**Amendments to the Drawings:**

## REMARKS/ARGUMENTS

Appl. No: 10/636,020  
Reply to Office Action of June 15, 2005  
Annotated sheet showing changes

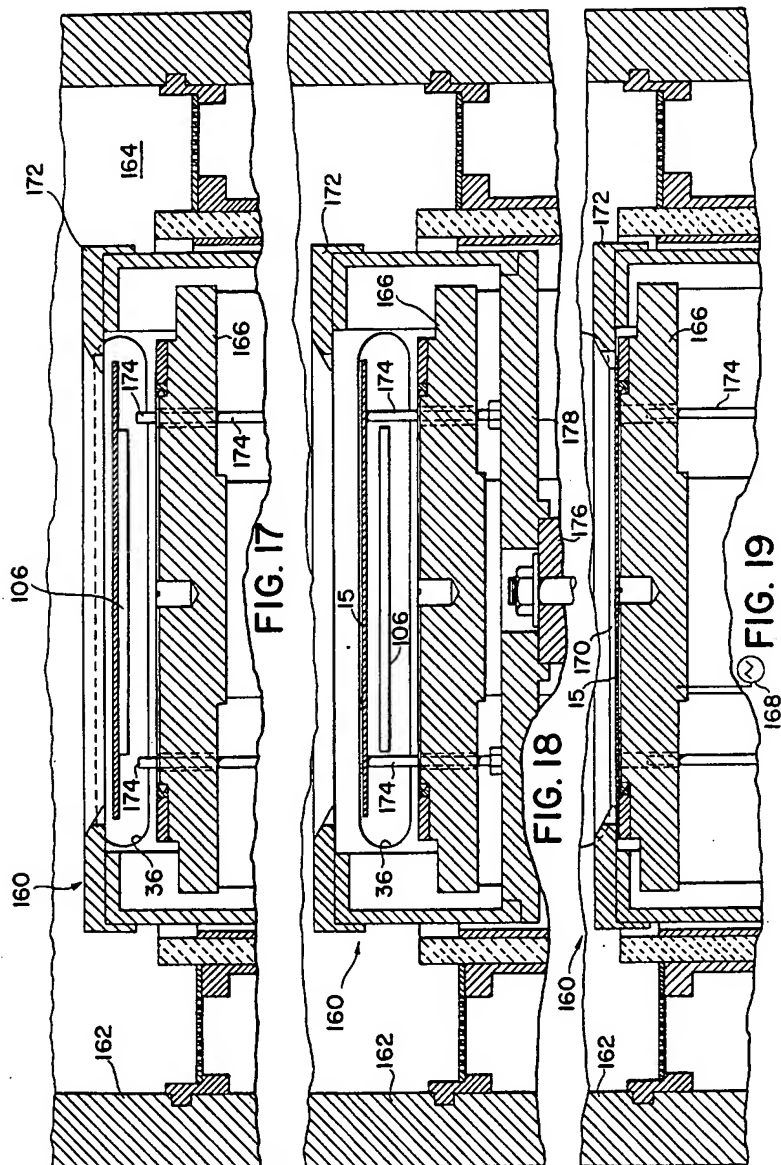
Cheng is also silent regarding the process chamber opening, but one can infer the dimension of the process opening by Maydan et al. (U.S. patent 4,951,601), which is made a cross-reference by Cheng. In Maydan, Fig. 16-19, sheet 6 of 7 (see figure attached), the process chamber opening 36 is only slightly larger than the workpiece 15, therefore could not accommodate the shield 3 to 4 times larger in diameter than the workpiece. Using this information, together with Cheng's silence on the subject, the Applicant submits that no one skilled in the art could anticipate or render obvious that Cheng's shield can be replaced in the same way as the replacement of the workpiece.

Cheng is also silent regarding the way the workpiece and the shield can be replaced. Using the same information from Maydan (Fig. 16-19, sheet 6 of 7), the workpiece 15 is shown

Fig. 2 (Prior Art)

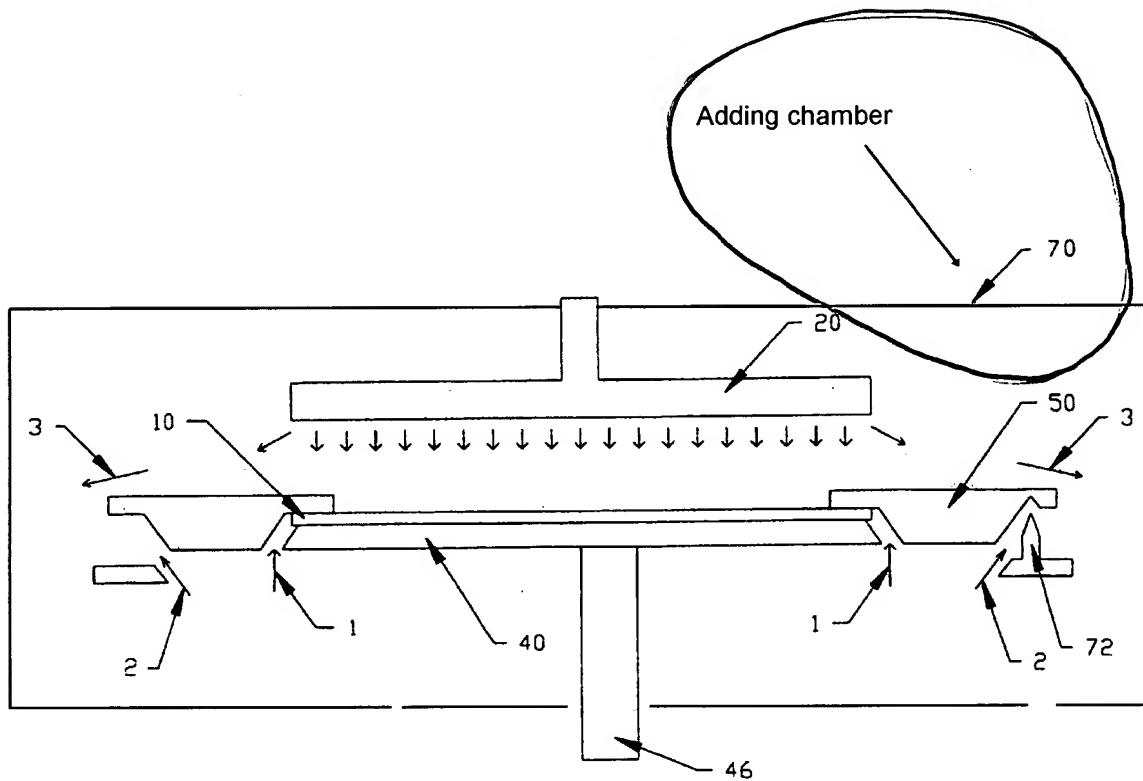
In Fig. 2, the drawing of a chamber 70 has been added. In Figs. 4-6, the drawing of a chamber 200 has been added.

(1) With regard to the objection of the drawings under 37 CFR 1.83(a), Applicant has amended the drawing to overcome the Examiner's objection. Specifically, Applicant has added a chamber drawing 70 and 200 to Fig. 2 and Figs. 4-6, respectively.

The support for the chamber 70 in Fig. 2 is from the paragraph [0006] (as numbered in U.S. Patent Publication No. US 2002/0179014), discussing the drawback of the prior art of Fig. 2, that the chamber 70 needs to be vented before shield replacement, and then chamber 70 needs to be pumped down and conditioned for process qualification. Paragraph [0006] also has been amended to add the reference sign 70 to the chamber of Fig. 2.

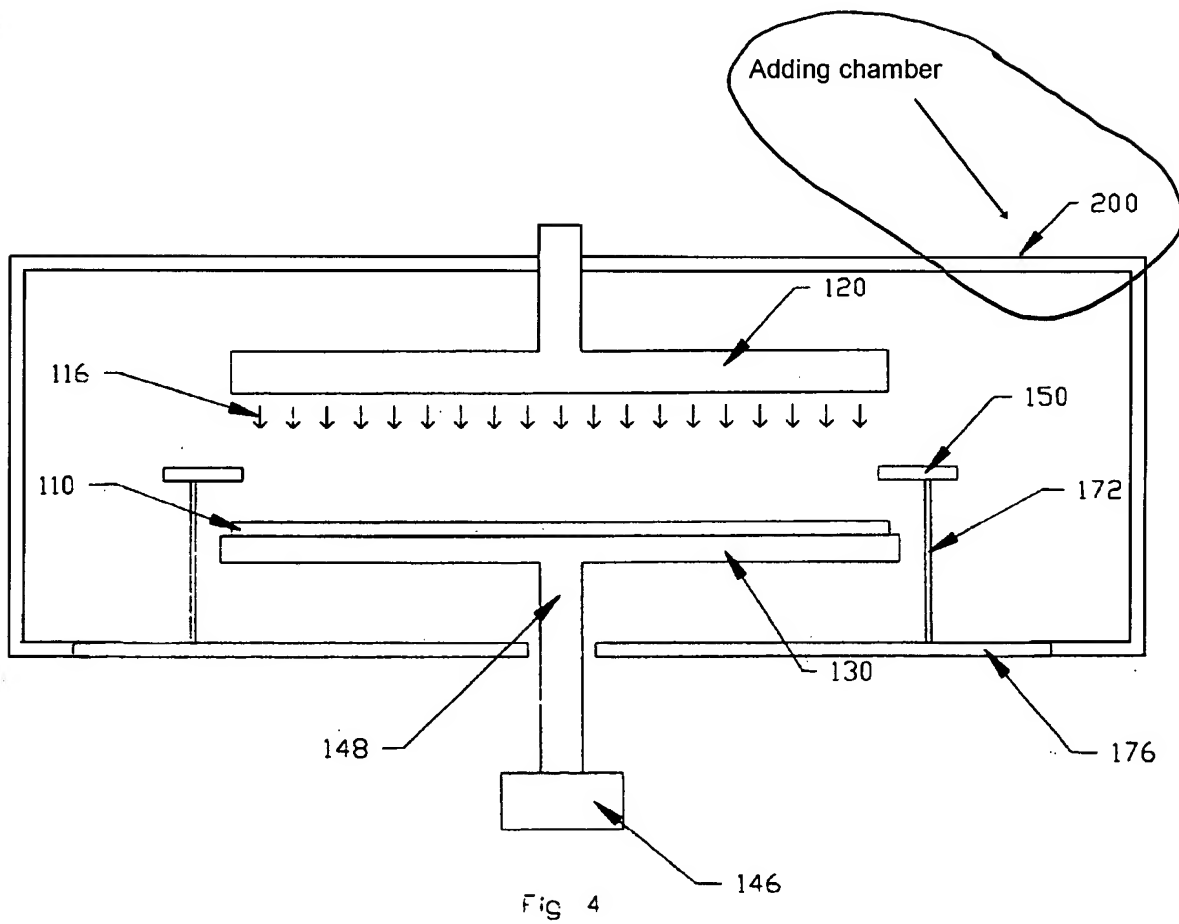
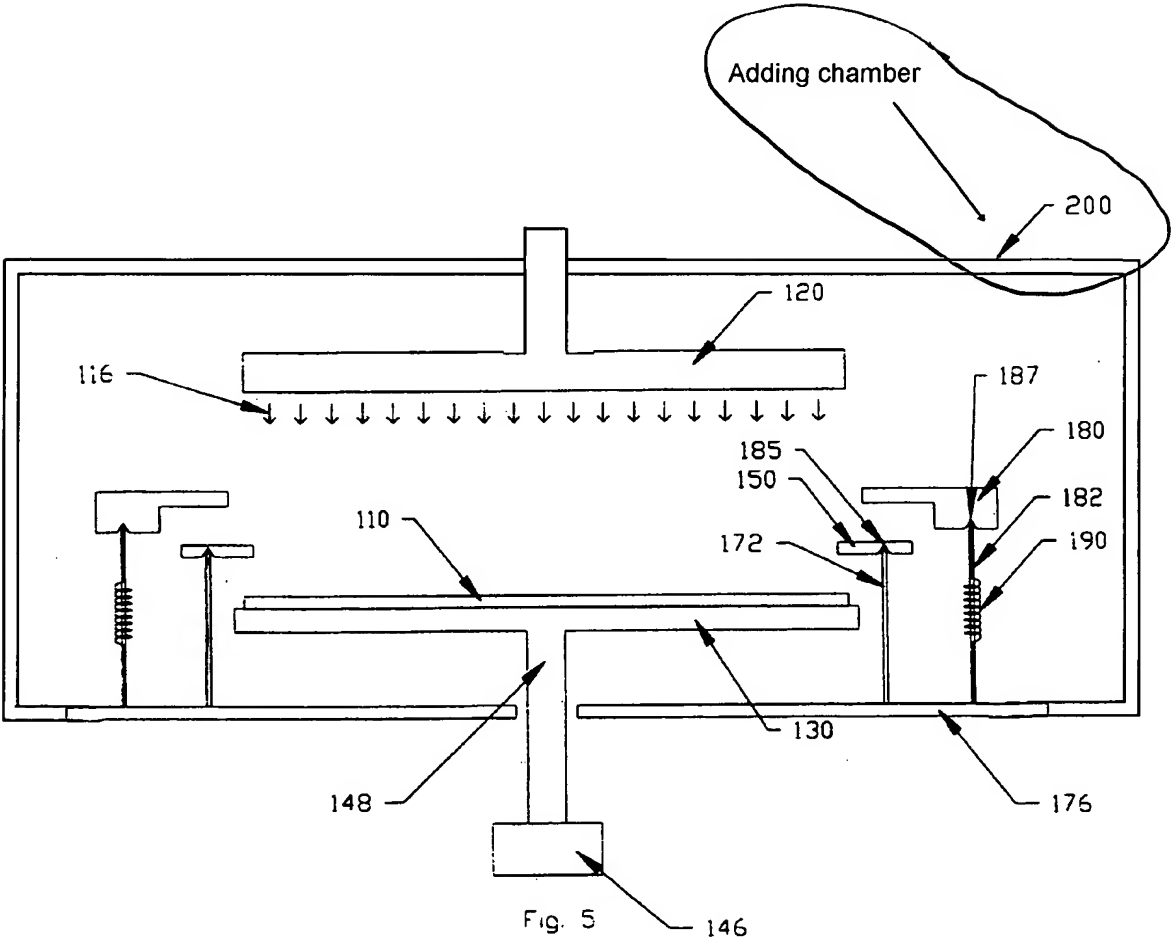
The support for the chamber 200 in Fig. 4 is from the paragraph [0040] (as numbered in U.S. Patent Publication No. US 2002/0179014), discussing the apparatus. The apparatus comprises *a stationary wall 176 such as a chamber wall*. Paragraph [0040] also has been amended to replace "chamber wall" with "wall of the chamber 200", showing the reference sign 200 to the chamber of Fig. 4.

The support for the chamber 200 in Fig. 5 is from the paragraph [0041] (as numbered in U.S. Patent Publication No. US 2002/0179014), discussing the apparatus with the mentioning of the wall 176. Fig. 5 shares many common fixtures with Fig. 4, and thus “the wall 176” in paragraph [0041] also has been amended to be replaced with “the wall 176 of the chamber 200”, showing the reference sign 200 to the chamber of Fig. 5.

Fig. 6

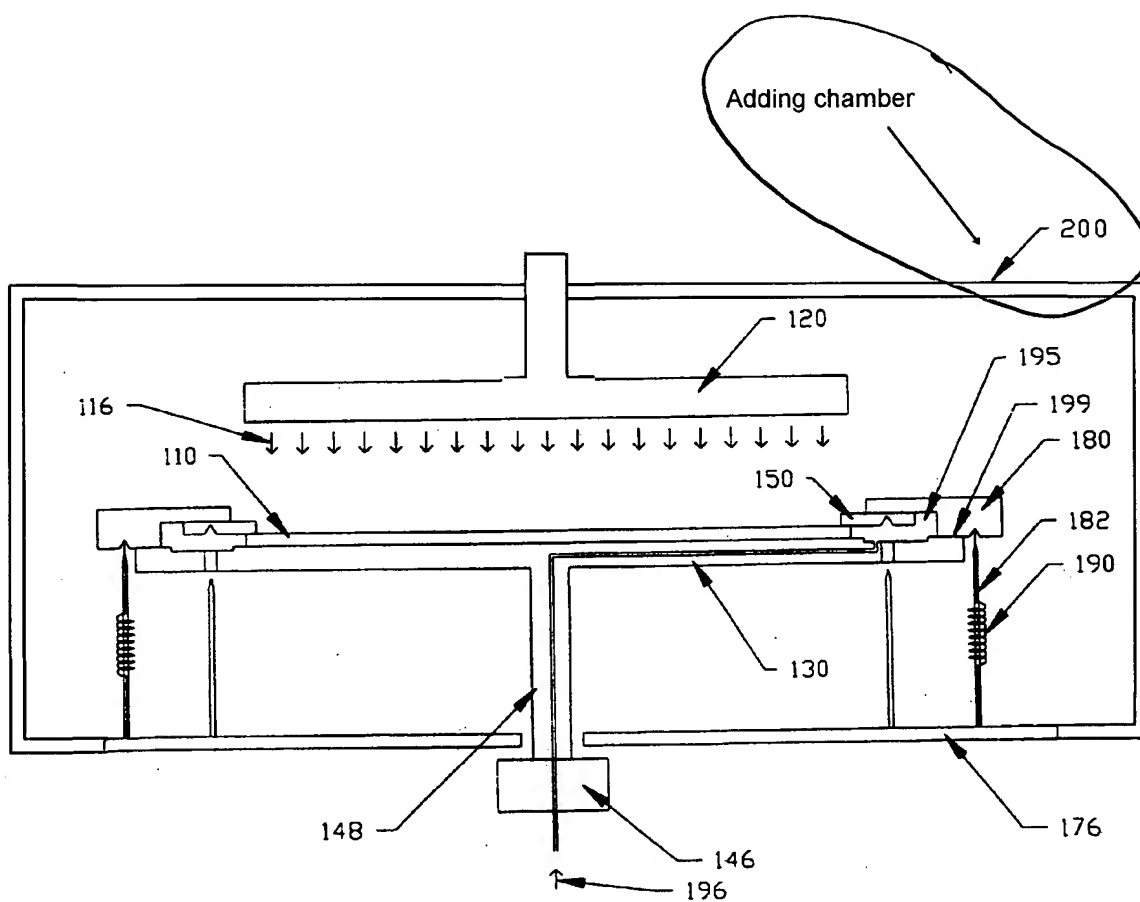
The support for the chamber 200 in Fig. 6 is from the paragraph [0042] (as numbered in U.S. Patent Publication No. US 2002/0179014), discussing the pressure difference between the cavity and the chamber pressure. “*The cavity 195 retains the purging gas, created a higher pressure in the cavity 195 than in the chamber.*”. Paragraph [0042] has been amended to replace “the chamber” with “the chamber 200”, showing the reference sign 200 to the chamber of Fig. 6.
